Florida Department of Transportation

Reference: Significant Deficiency Notification
District 1 Local Government Owned Bridge Inspection Program
Bridge ID: 175049 S Sumter Blvd Over Cocoplum Waterway

Photo 1: Elevation

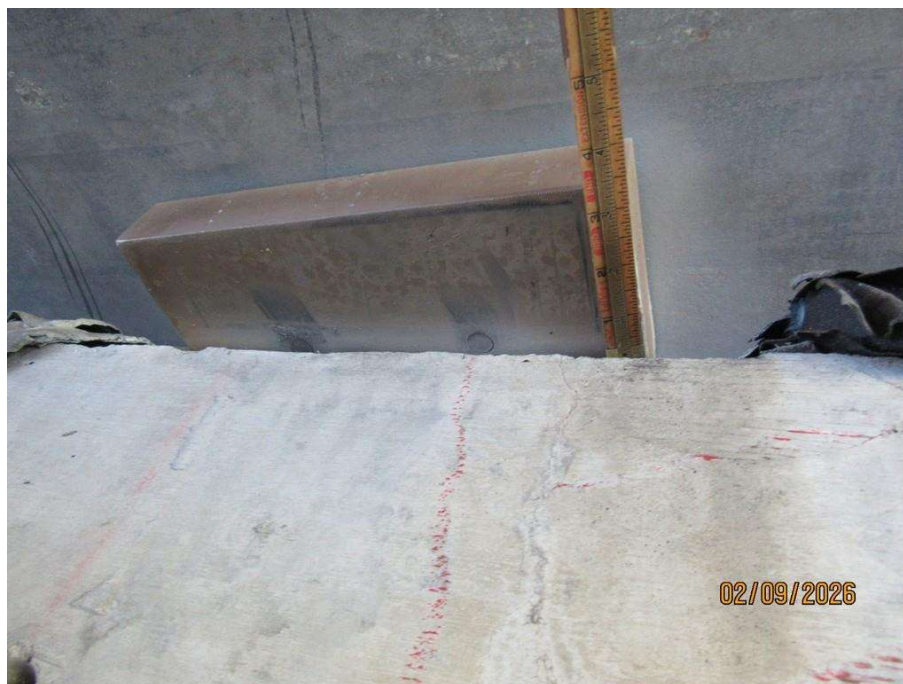
- Bearing issues: Bearings 1-1 through 1-4 and 1-9 at Abutment 1 are walking out. The bearings are 10in. long x 6in. wide.
- 2022 inspection noted as 2in. loss of bearing
- 2024 inspection noted Bearings 1-2 and 1-3 up to 2-3/4in. loss of bearing.
- 2026 inspection identified five bearings with loss of bearing measuring up to 3-1/4in., with most of the remaining bearings right at the edge.

Although this condition does not warrant a Prompt Corrective Action notification at this time, it is a condition that warrants notification in advance of receiving the inspection report so repairs can be made as soon as possible. Please notify me in writing of the action taken and the date the action was completed. Help us protect your federal funds and reduce your potential legal liability by expediting this requested response. Should any questions arise, please contact me at email address Daniel.Buidens@dot.state.fl.us or at phone number (813) 612-3373.
